**GOLF HAMMOCK
UNIT TWO**
AMERICAN HOME SERVICE CORPORATION
HIGHLANDS COUNTY, FLORIDA

*APPROVED AS NOTED
12-27-77 [Signature]
"FIELD COPY"*

STREET & STORM WATER DRAINAGE PLAN		DES. RHM	DWN. WKM
GOLF HAMMOCK UNIT 2		APP. RHM	
HIGHLANDS COUNTY, FLORIDA		DATE DEC. 16, 1977	
FOR: AMERICAN HOME SERVICE CORP.		PROJECT NO. 077.2-77	
		DRAWING NO. PD-1	
		SHEET 1 OF 4

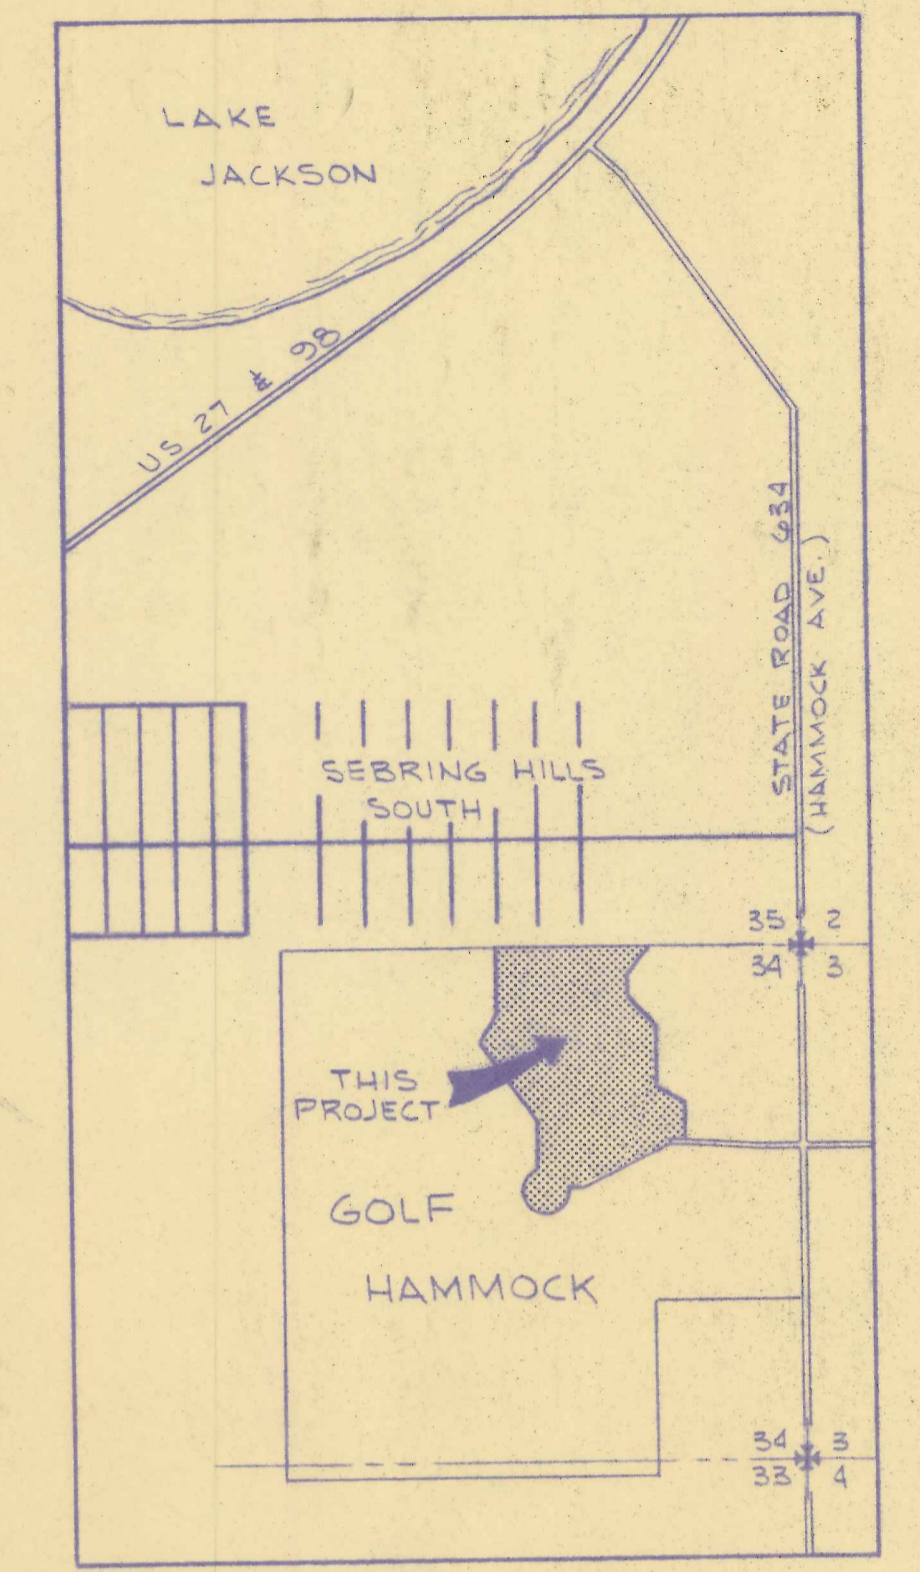
NOTES: (1) BACKYARD EASEMENTS TO BE 20'
(2) ADD ROAD SIGN DETAILS AND SIGN LOCATIONS
